Carp River and Carp Creek 2024 Floodplain Mapping Presentation to the MVCA Board

Faith Blacquiere
B.H.Sc. BLS
Glen Cairn, Kanata
8 July 2024

Map 42

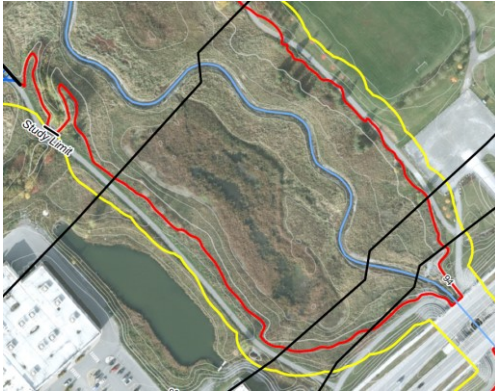
- 2 parcels have Spill Areas
 - Richcraft 1620 Hazeldean (blue In Process)
 - 395 Didsbury (pink To Be Determined)
- Removal of spill areas results in loss of storage and higher water levels
- The number of To Be Determined (pink) parcels is a major concern as these may or may not (e. g. City lands) be filled
- The Maple Grove Road widening and Transitway may impact water levels and floodplain capacity in future

Map 45

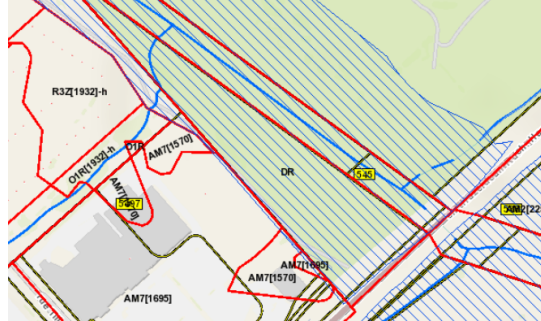
- The West Pathway Map 45 is **94.41m** vs the 2015 Tender **93.75m** – the pathway should have been overtopped
- The East Pathway 2015 Tender has differences from Map 45 **94.41m** in 3 locations
 - 94.75 **-0.34** should not be in floodplain
 - 94.10 **+0.31** should be in floodplain
 - 93.75 (3) **+0.66** should be in floodplain
- Pathway elevations may have impacted the corridor width and affected flows

Map 42

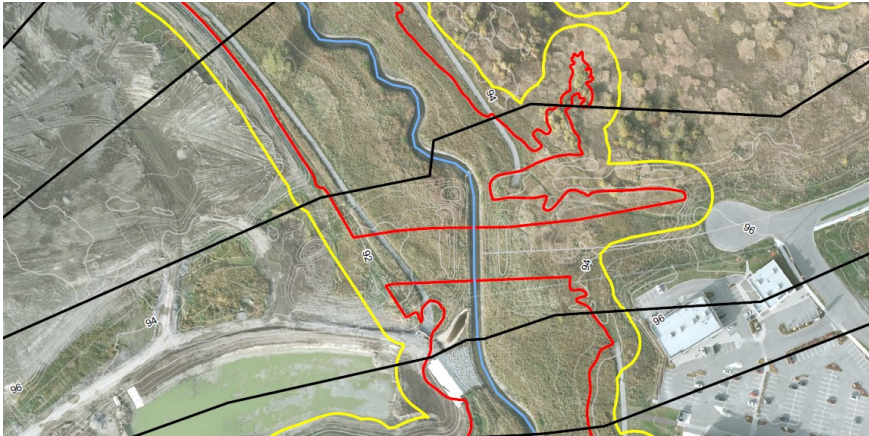
- Map 42 flood levels are higher than the MVCA Permit **100-yr 93.50m**
 - u/s 42807 **93.83m** minus 93.50m is **+0.33m higher**
 - d/s 42692 **93.57m** minus 93.50m is **+0.07m higher**
- The pathways were 0.2m under water now will be **up to 0.53m under water**
- A large amount of fill was placed fill in the floodplain resulting in less storage and constriction of flow – did the Restoration studies account for it?
- The project started 31 Jan 2020 and was completed 2 Sep 2021 – why weren't the new floodlines reflected in the 2024 study?

Map 47 Old Colony to Castlefrank

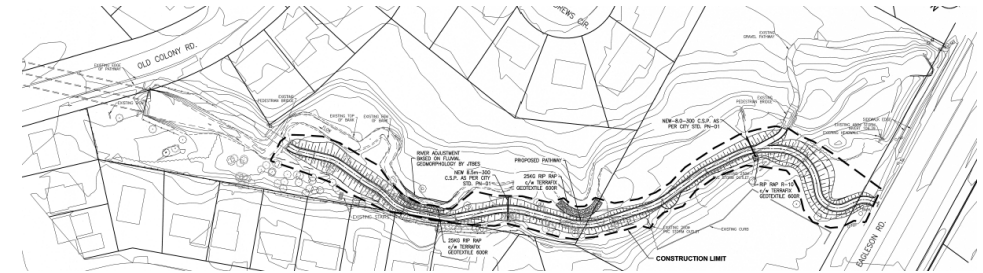
- The CCL 2003 modelling modified the Carp Creek channel in response to the 1996 and 2002 flooding to lower the water levels
 - u/s Castlefrank **100.45 is 0.46m higher than Map 47 99.99m**

- The 2011 Bank Failure Assessment [ref CC EMB Pg 15] (d/s) **100yr 102.23m is 2.34m higher than Map 47 99.89m**
- The Carp Creek Restoration Addendum Mar 2021

- u/s 101.14 (EC and FC) is **0.62m higher than Map 47 100.52m**
 - d/s 100.97(FC and EC) is **2.08m higher than Map 47 98.89m**
- 2024 water levels were **higher by 0.06m to 0.86m (3) u/s of Old Colony and lower from Old Colony to Terry Fox Drive by 0.08m to 1.2m (5)**

- Pedestrian bridges (2011, 2020), Ravine Park fill (2007) and Pathway (2014) and Carp Creek Restoration (2021) resulted in storage loss while the 2009 flood mitigation added more flow to the channel

- Due to these projects, sediment buildup, islands and storage loss the **2024 water levels should have been higher**

Map 46 extract

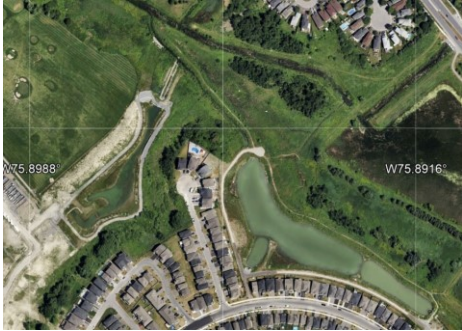
- MVCA **1983 water level 95.20m** was used for Pond 2, Pond 3, the CRWT channel, the Golf Course Pond and Grant Crossing Pond – the **2024 water level of 95.55m is 0.35m higher**

- Map 46 has **95.55m** on the downstream side of the Glen Cairn Detention Basin outlet culvert then **94.56m, a decrease of 0.99m** – is this physically possible?

- Map 46 has **95.57m** and **96.56m** in the Basin downstream of Terry Fox Drive – can water levels differ in a basin?
- Past Restoration studies have confused the water levels upstream in the Glen Cairn Detention Basin with those downstream at the culvert outlet

Map 46 extract

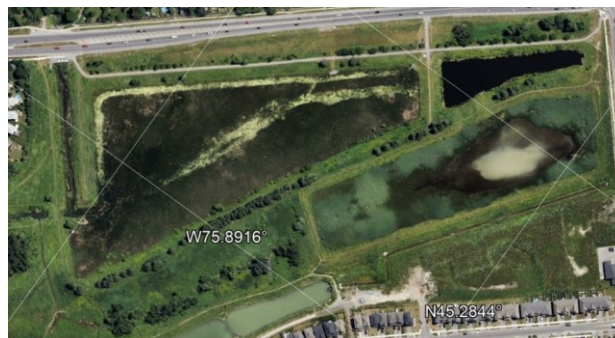
- The Glen Cairn Detention Basin capacity is uncertain
 - The **bottom is 0.3m higher than design** (City staff Nov 2009)
 - The outlet culvert sizes **1500mm** (2009 Survey, measured 20240615) vs **1200mm** (PCSWMM 2015)
 - The berm between the wet pond and north dry pond was expanded with no compensation
 - The “dry pond” west of the wet pond built on floodplain and incoming tributaries is rarely dry so has less capacity
- The outlet culverts invert differ from CH2MHILL Oct 2005
 - west **92.59m vs 92.87m is an increase of 0.28m**
 - east **92.64m vs 92.94 an increase of 0.3m**
- **The Nov 2009 survey has 17 points north of the wet pond that are less than 95.55m so the Detention Basin will overflow**
- The 2009 flood mitigation Stormwater Pumping Station was designed to maintain the water level at 93.50m upstream of the berm with no analysis of impact
